**Australian Energy Regulator**

**Victorian Electricity Transmission Revenue Reset**

**SP Ausnet Application**

**A response**

**Table 12.10: Comparison of historic and future prices (\$m/MWh)**

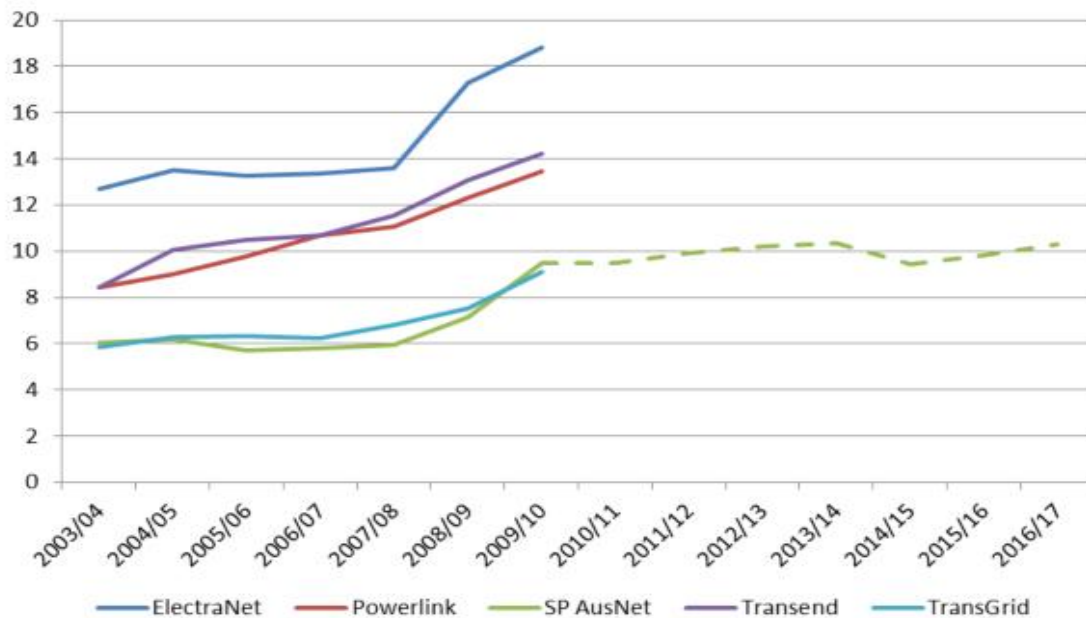
The two aspects that this figure shows is that SPA, previously the lowest cost provider of electricity transmission in the NEM, is now the second least expensive. This growth in cost is despite SPA having a much denser consumption of electricity than TransGrid (its closest comparator) or any of the other TNSPs, and therefore should have the lowest unit costs.

It also shows that the historic cost of ~\$6/MWh in 2007/08 has risen by a staggering 70% in the past 5 years. In comparison, price rises in all other TNSPs have increased at much lower rates. In 2007, the EUCV pointed out in its response to the SPA application for the current period, that SPA was unjustifiably claiming a massive increase in its costs, even accepting that there was an increase in consumption forecast. The AER therefore needs to assess this application on the basis that the cost rise in the last period (AA3) is demonstrably excessive.

For SPA to state that its costs reflects a reduction in the first year of the next period and only modest increases thereafter, belies the fact that its cost structure is massively above (in proportional terms) what it was before the current reset period.

**Figure 3-11 — Victorian annual energy projections**

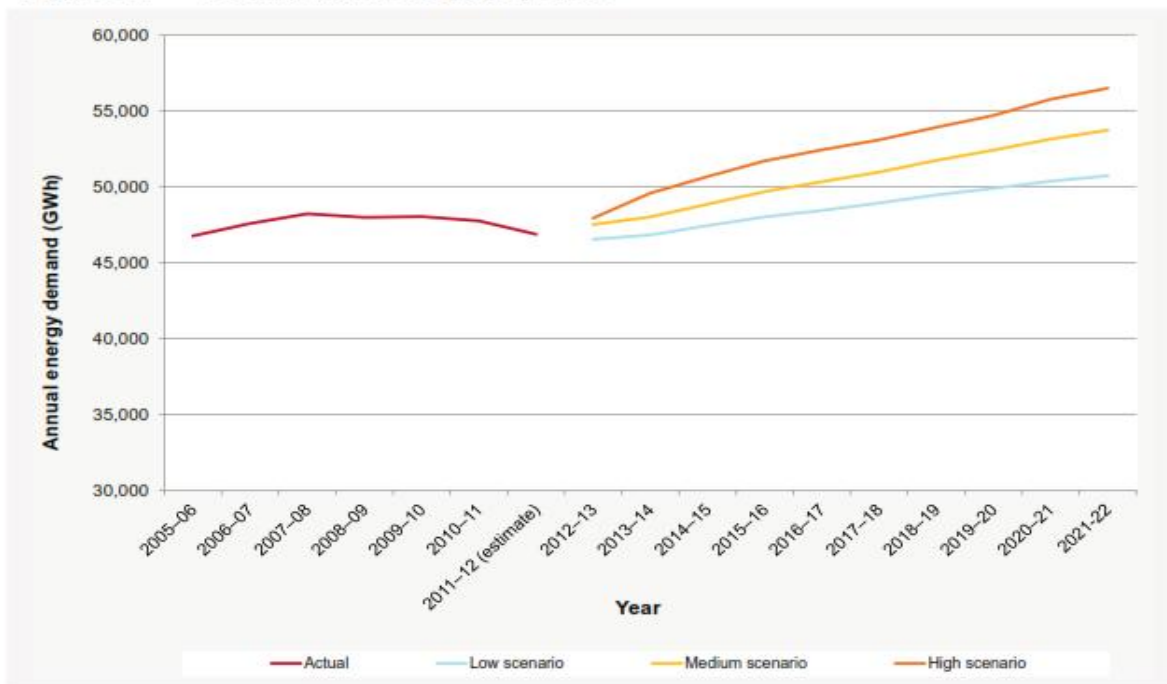
The impact of this declining consumption during the current period results in a significant increase in unit costs (\$/MWh) to consumers. The proposal by SPA

marginally reduces the unit costs (a result stemming from the low risk free rate) whilst opex and capex costs both increase.

The expected consumption by the end of the next (three year) period is forecast by AEMO to be much the same as at the start of the current period, so the opex and capex SPA is claiming for the next period are overstated relative to those costs they had early in the current period.
